SITE PLAN REVIEW

LOT GRADING PLAN
67 DEGREY DRIVE

GREENYORK HOMES
DEGREY DRIVE,
CITY OF BRAMPTON

LOT 22

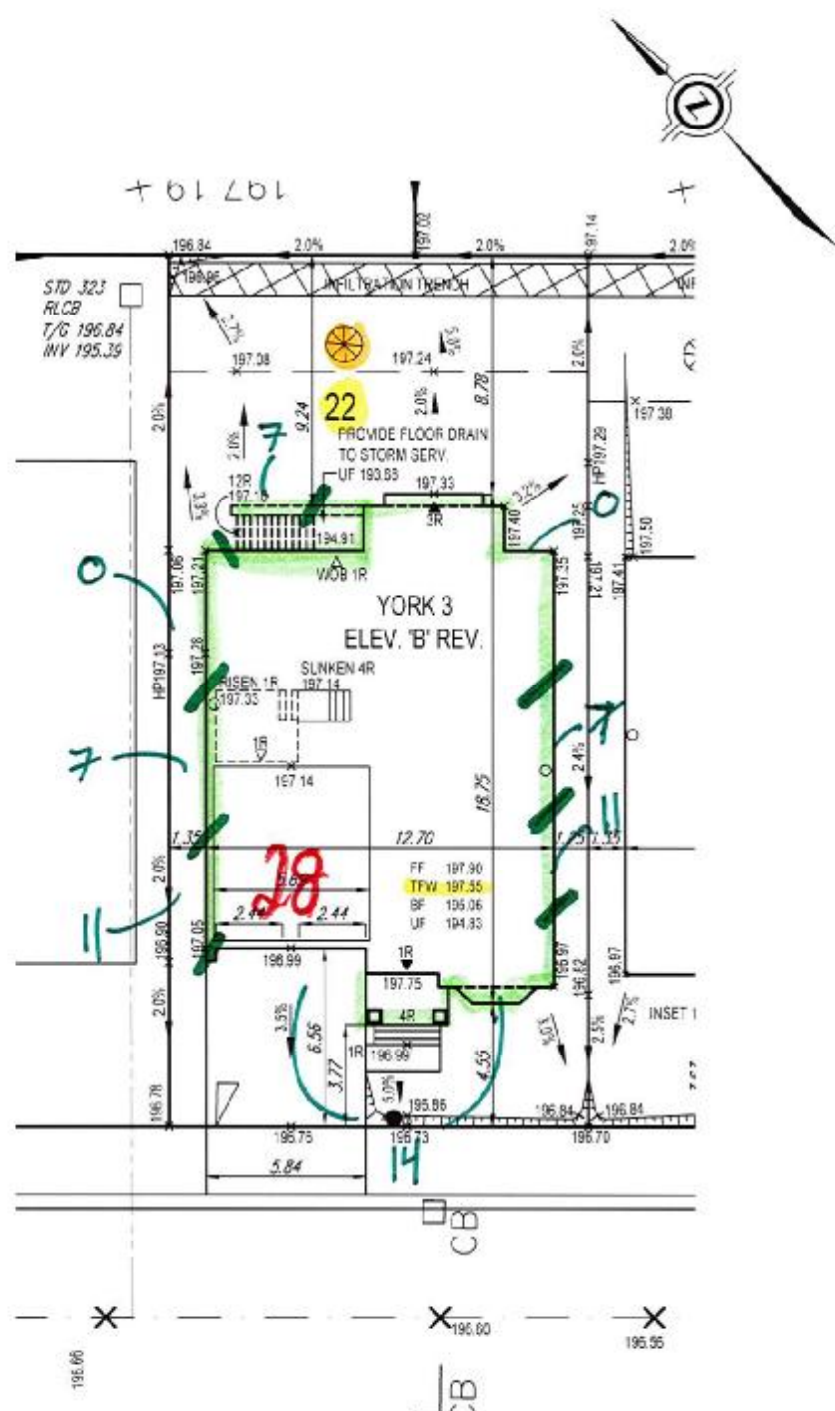
SAN INV = 194.03 ✓ **.80**
STM INV = 194.23 ✓ **.60**
